Access Compliance Report

Public Rights-of-Way

Intersection ID: 48955	Main Street: ROYA_PL	Cross Street: DAVID_JENNINGS_AV	Location: NW
ADA ID: 97932819DBE9	Ramp Type: Perp	Initial Pass/Fail: Fail	Overall Compliance: No
			Severity Score: 21.25

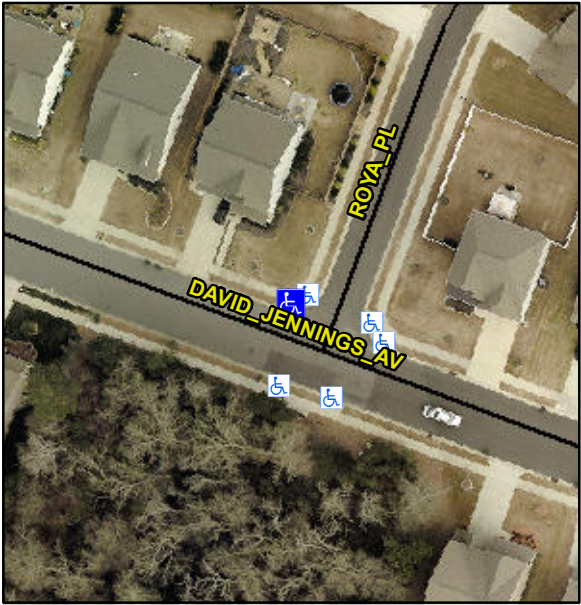
Codes/Mitigation Info/Possible Solution		Field Measurements/Component Compliance			
	Possible Solutions:				
	Remove & Replace Entire Ramp.				
	Surveyor Notes:				
	N/A				
	PROW/ADA:				
	Not Found, R304.5.1, R304.2.2				
Street 1 Name	DAVID JENNINGS AV				
Stop Condition-Street 2	None				
Street 2 Name	N/A				
Stop Condition-Street 1	N/A				
Total Cost:		\$	1850.00

Compliance	Description	Data	Compliance	Description	Data
N/A	Ramp Length (in)	46.5	No	Ramp Slope (%)	8.9
No	Ramp Width (in)	47.5	Yes	Ramp XSlope (%)	1.4
N/A	Flare Type LT	N/A	N/A	Flare Type RT	N/A
N/A	Flare Slope LT (%)	N/A	N/A	Flare Slope RT (%)	N/A
N/A	Flare Traversable LT?	N/A	N/A	Flare Traversable RT?	N/A
N/A	Landing Length (in)	N/A	N/A	DWS Provided?	N/A
N/A	Landing Width (in)	N/A	N/A	DWS Contrast?	N/A
N/A	Landing Slope (%)	N/A	N/A	DWS Length (in)	N/A
N/A	Landing X Slope (%)	N/A	N/A	DWS Full Width?	N/A
N/A	Landing Curb? (Y/N)	N/A	N/A	DWS Offset (in)	N/A
N/A	Shared Landing?	N/A			
N/A	Gutter Ponding?	N/A	N/A	Gutter Slope (%)	N/A
N/A	Gutter Lip Ht (in)	0.5	N/A	Gutter X Slope (%)	N/A
N/A	Painted X Walk1?	No	N/A	Painted X Walk2?	N/A
	X Walk 1 Direction	To SW		X Walk 2 Direction	N/A
N/A	X Walk 1 Width (in)	N/A	N/A	X Walk 2 Width (in)	N/A
	X Walk 1 Slope (%)	5.5		X Walk 2 Slope (%)	N/A
	X Walk 1 X Slope (%)	2.6		X Walk 2 X Slope (%)	N/A
